New Reactor Division – Generic Design Assessment
Step 2 Assessment of the Civil Engineering of UK HPR1000 Reactor

Assessment Report: ONR-GDA-UKHPR1000-AR-18-005
Revision 0
October 2018

Figure 1 – General Layout of HPR1000 (FCG3) (Ref. 12)

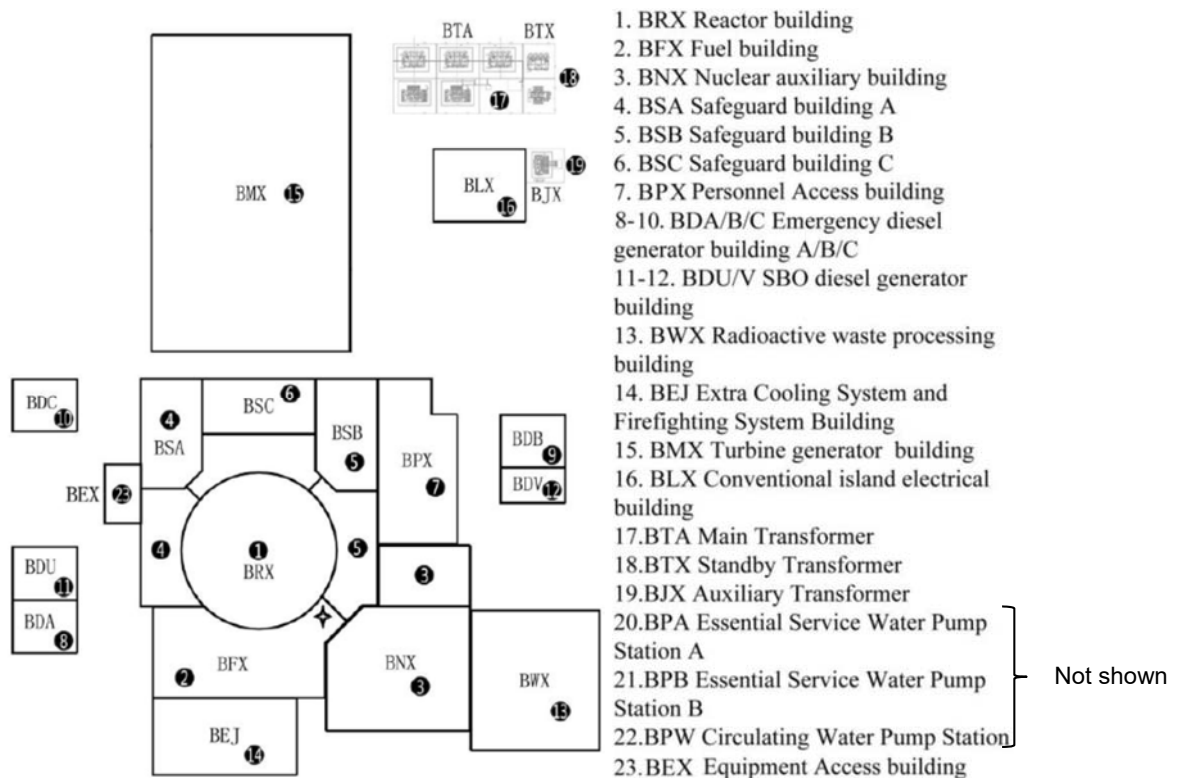
41. I have not assessed the general layout during GDA Step 2 and this will be subject to further examination in GDA Steps 3 and 4; particularly on claims made within the aircraft impact safety case.

83. The PSR (Ref. 12) identifies that the following buildings are protected from aircraft crashes (see Section 4, Figure 1 for reference general layout):
